MAJOR PROJECT ASSESSMENT: Camellia and Rosehill Recycled Water Scheme

Director-General's
Environmental Assessment Report
Section 75I of the
Environmental Planning and Assessment Act 1979

May 2009

Figure 5: Revised Plant Layout

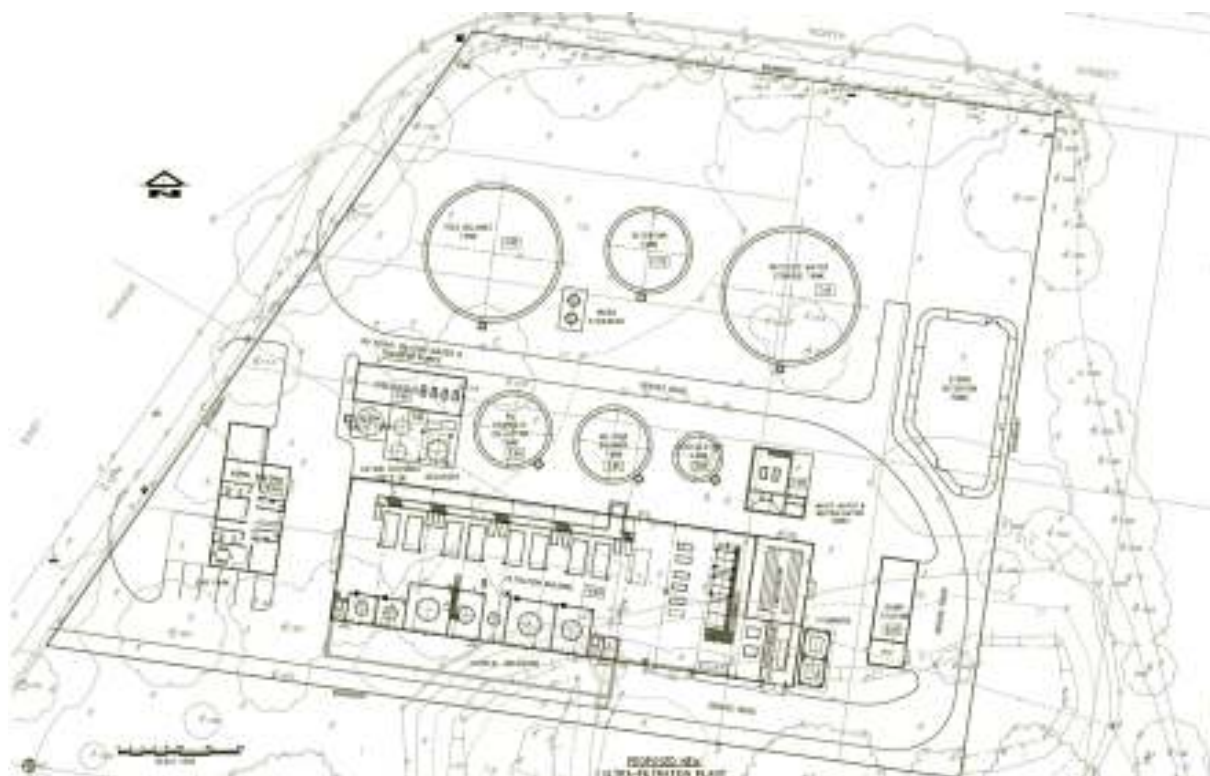
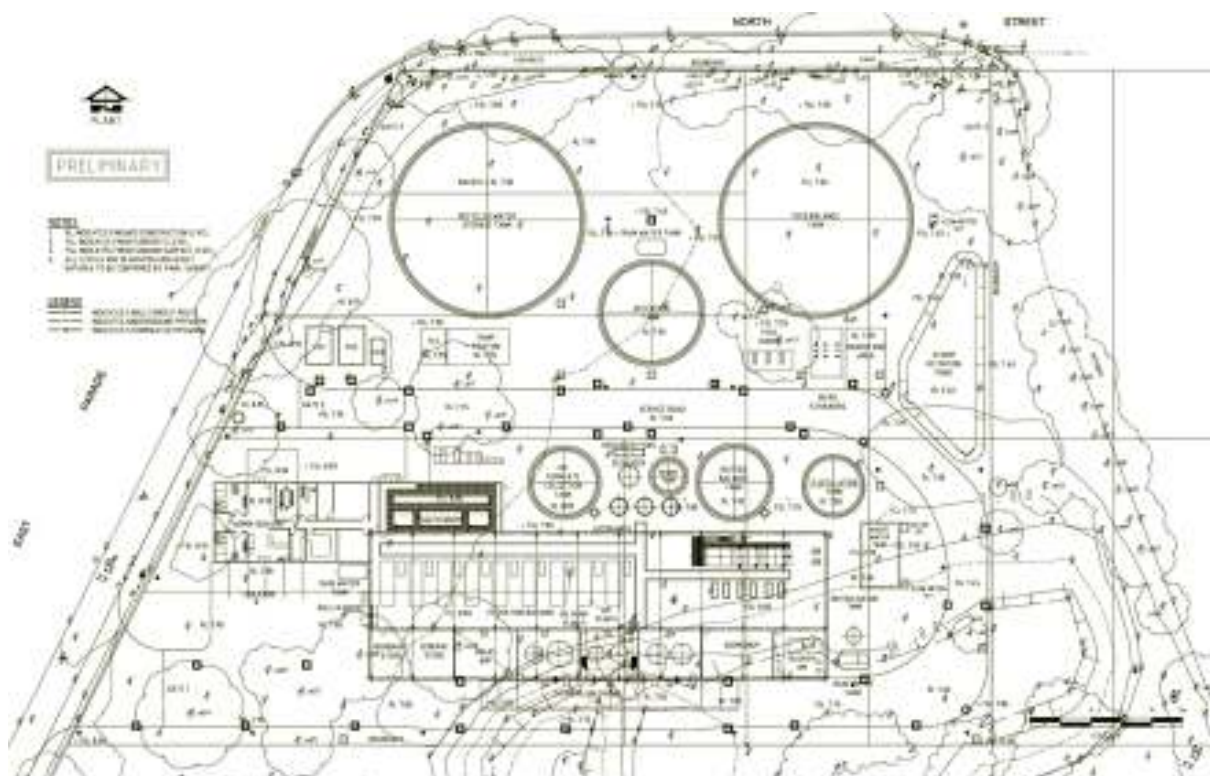
The electricity provider for the proposed RWTP at Fairfield indicated that the proposed high voltage power supply for the plant would not be acceptable and also transformers must be directly accessible from the existing road network without accessing the plant. Therefore a low voltage system has been adopted and the plant redesigned accordingly. The plant design has been revised to accommodate the requirements of the energy provider. The original proposal included a high voltage transformer located immediately east of the main filtration building in the south eastern portion of the site. The revised design now includes three low voltage transformers (2 x 1250kVA and 1 x 500kVA) located on the western boundary of the site off East Parade. The revised transformer location and configuration is outlined in the revised plant design plans shown in Figure 4 below.

As a result of the transformer relocation and the drop in voltage, the pumping station also required relocation. The pumping station was originally proposed for the south eastern corner of the site. A new position close to the new transformer location on the western boundary of the site has been adopted with consideration of impacts on residences along the northern side of North Street. The revised location between the recycled water storage tank and the main filtration building directly adjacent to the transformer is shown in Figure 4. This provides visual screening and noise attenuation for the adjacent residents along North Street. Additional noise modelling has been undertaken to quantify any potential impacts and is provided in the Preferred Project Report.

The original pumping station was proposed to be housed inside an open sided structure. However potential exceedance of night-time operational noise design goals and the revised location significantly closer to potential

residential noise receivers along North Street and Railway Parade has necessitated a fully enclosed and acoustically designed structure around the pumps to attenuate pump noise. This change has also been taken into account in the additional modelling.

Relocation of the transformers and the pumping station has necessitated a change to the plant layout in order to maintain sufficient clearance between the various plant components. Specifically the configurations and dimensions of structures have changed. To reduce energy requirements the heights of the recycled water storage tank, feed balance tank and detention tank have been reduced. To maintain storage volumes, the diameters of the tanks have increased accordingly.

The revised layout potentially affects the visual amenity of the site. In general, the heights of all the tanks, buildings and other structures proposed at the Fairfield RWTP have been reduced in the revised design, and the overall silhouette of the plant will be more compact. Revised section and elevation plans are provided in the Preferred Project Report. A summary of revised heights and height changes is provided in Table 2 below.
